## INNOVATIVE RESEARCH JSP26-05

Consideration at the request of Innovative Research for approval of the Preliminary Site Plan and Stormwater Management Plan. The subject property, located at 46460 Peary Court, consists of approximately 0.97 acres and is situated north of West Road and east of Hudson Drive (Section 4). The property is zoned I-1 (Light Industrial). The applicant proposes to construct a 9,000 square foot one-story building on a vacant lot for biotechnical research.

## PLANNING REVIEW

**Review Date:** March 3, 2026  
**Review Type:** Preliminary Site Plan Review  
**Project Name:** **JSP26-05 Innovative Research** (46460 Peary Ct)  
**Plan Date:** January 27, 2026  
**Prepared By:** Diana Shanahan, Planner [dshanahan@cityofnovi.org](mailto:dshanahan@cityofnovi.org) (248) 347-0483

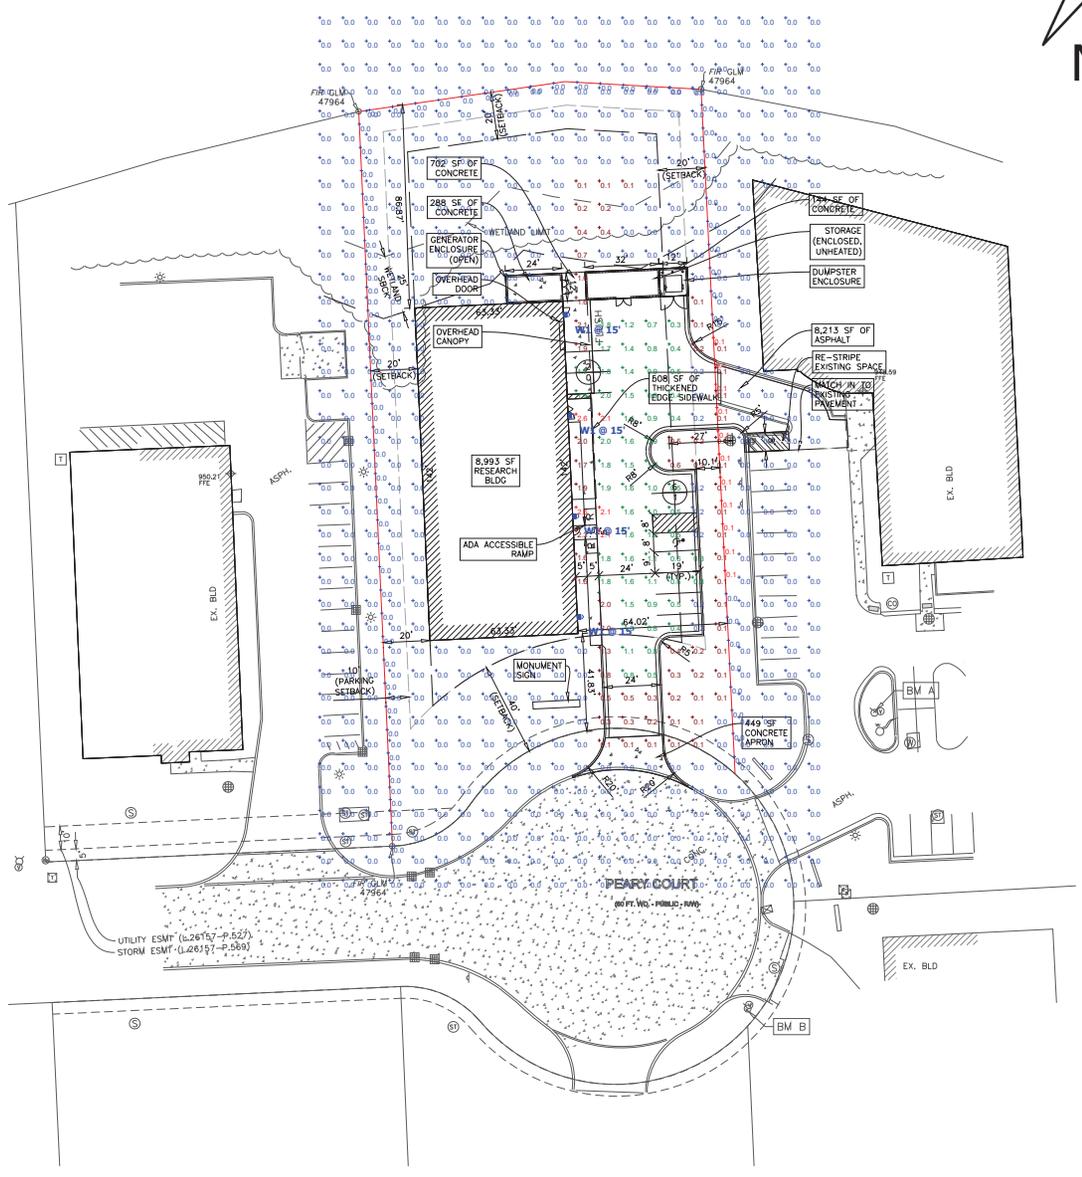
6. Exterior Lighting – Color Spectrum Management (Section 5.7.3.F): All permanent lighting installations in nonresidential zoning districts shall have a minimum Color Rendering Index (CRI) of 70 and Correlated Color Temperature (CCT) of no greater than 3000 Kelvin (K). Proposed fixtures indicate a CRI of 80 and CCT of 4000K. **Please revise CCT to meet ordinance standards.**

- a. The photometric plan will be updated to revise the CCT meeting the ordinance standards.
7. Bicycle Parking Lot Layout (Section 5.16.5.A)
  - a. Bicycle parking spaces are shown on sheet C-1.0.

Sheet No.  
 A-8

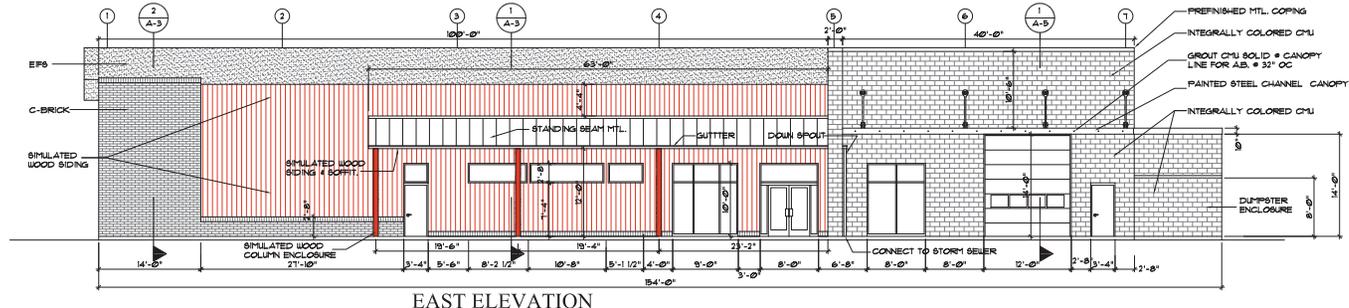
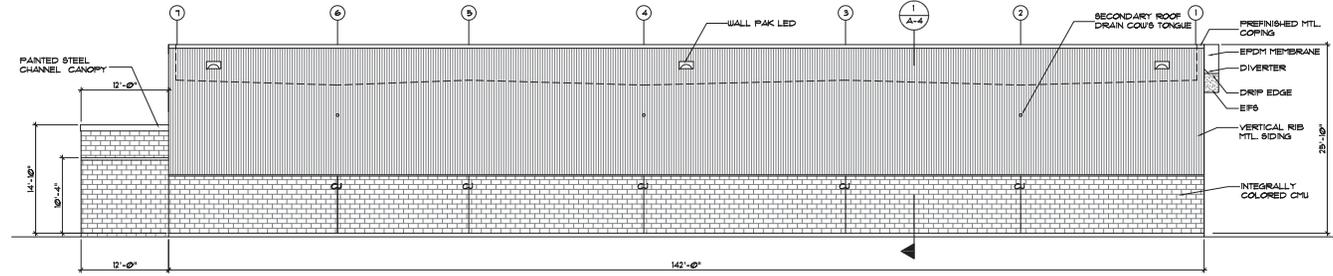
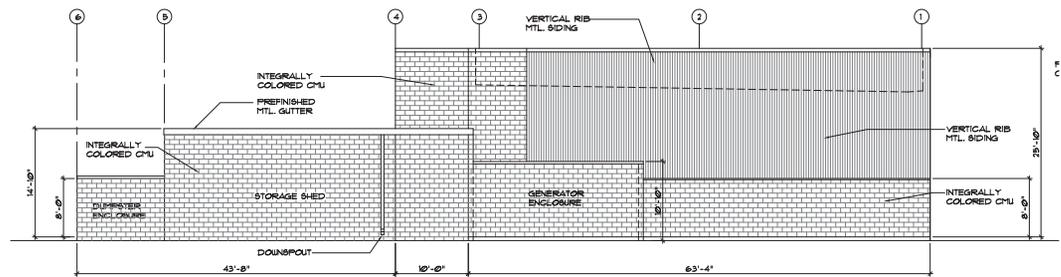
1. Section 9 Façade under Section 5.15.9 for overage of vertical metal rib siding on the west elevation (50% allowed, 67.6% proposed) and simulated wood patterned siding on the east elevations (25% allowed, 34.8% proposed) due to the utility nature of the building, which is hereby granted;
2. The Zoning Board of Appeals granting a variance from:
  - i. Section 3.6.2.E of the Zoning Ordinance to permit off-street parking within the front yard. (*Off-street parking is not permitted in the front yard of the I-1 Light Industrial district unless specific criteria are met; in this case, those criteria have not been satisfied*).
3. The findings of compliance with Ordinance standards in the staff and consultant review letters and the conditions and the items listed in those letters being addressed on the Final Site Plan; and
4. (*additional conditions here, if any*)

Section 9 Waiver is required for a the average of Vertical Metal Siding on the west facade (67.6 - 50 = 17.6%) and the average of Simulated Wood on the east facade (34.8 - 25 = 9.8%).

- The percentage of simulated wood patterned siding on the east elevation exceeds the permitted maximum (25% allowed, 34.8% proposed)As proposed, the design requires a Section 9 Façade Waiver. Refer to the Façade letter for additional information. **The Section 9 Façade Waiver will be subject to review and approval by the Planning Commission.**

1. Façade Waivers for 2 materials – We are requesting a section 9 Waiver for the overage of Simulated Wood Patterned Siding and Vertical Metal Siding. See attached Sheet A-8 revision dated 2/27/26. The sample board will be presented at the Planning Commission Meeting. Mr. Hall has recommended both waivers.

**Figure 2 – Beck North Northeast Basin and Aquaswirl**

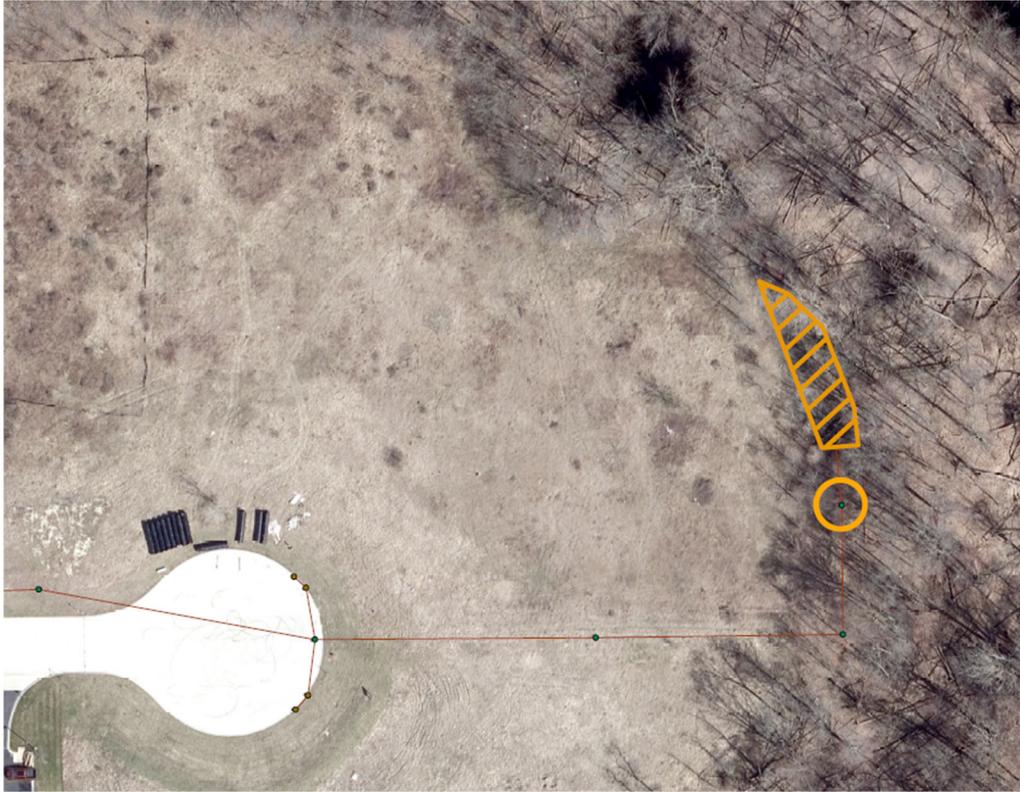
We have confirmed that the Aquaswirl structure (circled in orange in **Figure 2**) is filled with debris, in addition to the dissipation basin not being properly graded and had trees growing within the vicinity of the outlet structure.

Overdue maintenance of the dissipation basin and Aquaswirl structure is required. Maintenance should include, but is not limited to, cleaning the Aquaswirl structure to ensure its proper function, and grading and land clearing the dissipation basin to its original design.

**Figure 3 – Beck North Northwest Basin and Aquaswirl 2023**

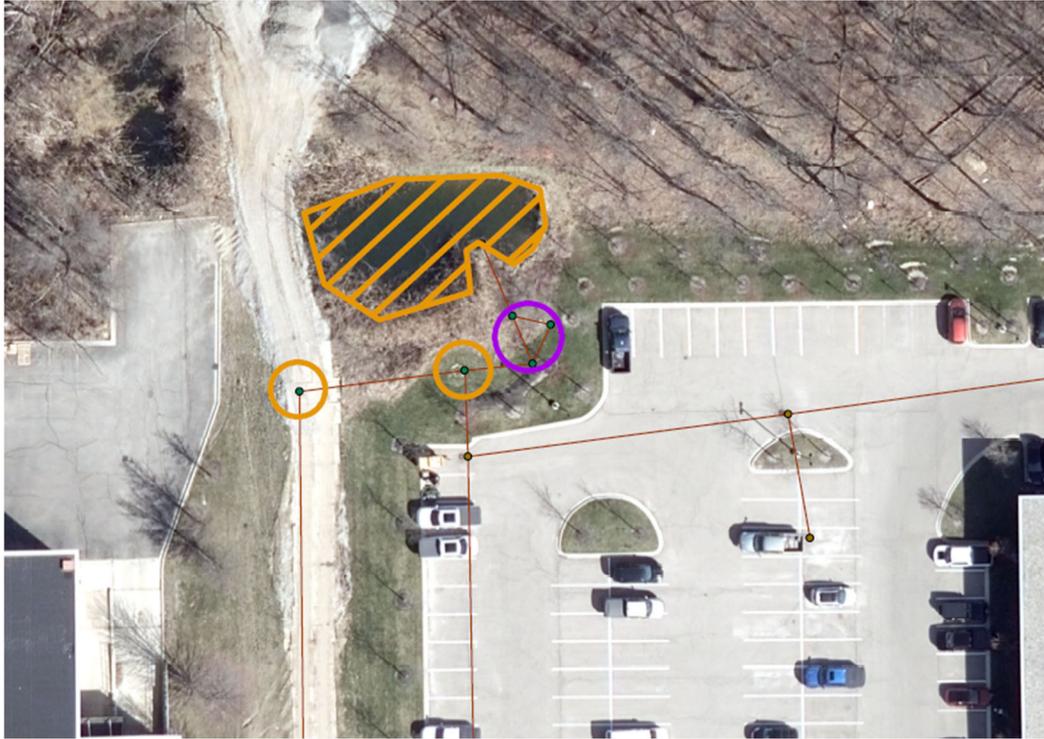
The Aquaswirl structure (circled in purple in **Figure 3**) has been covered in landscaping likely during the construction that occurred in 2015/2016. This structure will need to be unburied and properly maintained. In addition, the dissipation basin has not been properly maintained, causing the overflow to flow northwest to a separate basin north of the Brinkmann Pumps building and erode the soil between them.

Maintenance of the dissipation basin and Aquaswirl structure is required. Maintenance should include, but is not limited to, cleaning the Aquaswirl structure to ensure its proper function, grading and dredging the dissipation basin to its original design, and correcting the overflow from the basin so it will not erode the existing sediment.
